UNITED STATES PATENT AND TRADEMARK OFFICE

APPLICATION NO.	FILING DATE	FIRST NAMED INVENTOR	ATTORNEY DOCKET NO.	CONFIRMATION NO.
10/561,532	12/19/2005	Ronald Dekker	NL02 1153 US	9985
24738 7590 09/15/2010 PHILIPS INTELLECTUAL PROPERTY & STANDARDS PO BOX 3001 BRIARCLIFF MANOR, NY 10510-8001				
EXAMINER SHINGLETON, MICHAEL B				
ART UNIT 2815		PAPER NUMBER		
MAIL DATE 09/15/2010		DELIVERY MODE PAPER

Office Action Summary

DETAILED ACTION

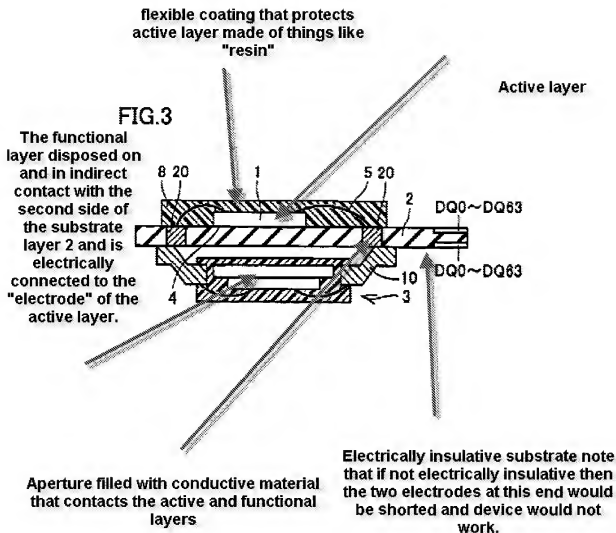
Claims 1 and 9 are rejected under 35 U.S.C. 102(e) as being clearly anticipated by Matsumoto US 6,798,679 (Matsumoto).

Claim 1 is so so extremely broad. First of all applicant still has not provided a proper drawing to an invention where the functional layer is on the "second side of the substrate". What applicant now points to as element 15 is composed of the same exact material as that of 14 with is pure conductor as presented by the original disclosure. This just cannot be the functional layer, period. Again what was shown in the original disclosure was that of pure conductor and thus there continues to be clear new matter that must be cancelled in response to this office action. However, as stated above claim 1 is so so so extremely broad. In essence claim 1 has a circuit on one side and a circuit on the other side of a substrate with a through hole connecting the two circuits. The only other thing added besides just stated is that there is a "flexible coating" formed on the "first side" of the substrate acting as a protective cover. Applicant should be well aware of the numerous flexible circuit boards that exist with through holes where the active or functional elements(layers) are mounted on both sides of the flexible circuit board and connected to each other via the through holes. More "rigid" versions like motherboards common in computers also are commonly known to exist with active and functional layers but all versions are flexible to some degree and applicant just has not claimed nor is there any support in the original disclosure to the degree, i.e. just how flexible is flexible as meant by applicant. The examiner wants to help applicant as much as possible to get to allowable subject matter and because there is no support for the degree of flexibility the examiner cannot suggest a limitation as to the degree as this would introduce new matter into the specification that has already been plagued with numerous errors. Matsumoto has been provided to show that the invention as set forth in claim 1, not withstanding the new matter that exists in the present application, is anticipated by the prior art. The following reproduced drawing should make it clear that claim 1 is clearly anticipated but a few points are discussed as well to further emphasis this point. Applicant says that the active layer includes "at least one switching element". Well many things can be consider a "switching element" and

as Matsumoto intends to use memory chips as the active layer the memory devices contained therein can be called "switching elements" as there state i.e. a 1 of a 0 is switchable. Resin is clearly flexible and is listed as one of the "flexible materials" by applicant. The term "monolithic" is likewise very broad. Clearly even applicant's invention is not "formed from a single crystal". Applicant's invention it is like that of Matsumoto "consisting of or constituting a single unit" i.e. monolithic. Should applicant like to have the examiner read a term like "monolithic" much more narrowly than is common practice then applicant should be aware of the recent case-law of Halliburton Energy Services, Inc v M-I LLC, Fed. Cir, 2007-1149 that states: "[b]ecause claims delineate the patentee's right to exclude, the patent statute requires that the scope of the claims be sufficiently definite to inform the public of the bounds of the protected invention, i.e., what subject matter is covered by the exclusive rights of the patent. Otherwise, competitors cannot avoid infringement, defeating the public notice function of the patent claims." As recited in the above Halliburton decision the court says "We note that the patent drafter is in the best position to resolve ambiguity in the patent claims, and it is highly desirable that the patent examiners demand that applicants do so in appropriate circumstances so that the patent can be amended during prosecution rather than attempting to resolve the ambiguity in litigation". Also note that the Halliburton decision relates to the situation where applicant is very specific as to specific limitations on structure that has already been "seen" and then the claims seems to recite functional language "at the exact point of novelty". Many times these types of claims are indefinite. Again the Halliburton decision states: Claims could be held indefinite "when the inventor is painstaking when he recites what has already been seen, and then uses conveniently functional language at the exact point of novelty". The Halliburton decision recited two Supreme Court cases that "identified the dangers of using only functional claim limitations to distinguish the claimed invention from the prior art" and these are General Electric, 304 U.S. at 371 and United Carbon, 317 U.S. at 234. What is needed in this application is clear limitations to positive structure in the claims that can distinguish the claimed invention over the prior art, i.e. the claimed positive limitations to structure that will not read on the prior art and as stated above applicant is in the best position to resolve ambiguity in the patent claims for the examiner just cannot read limitations into a claim that are just not there.
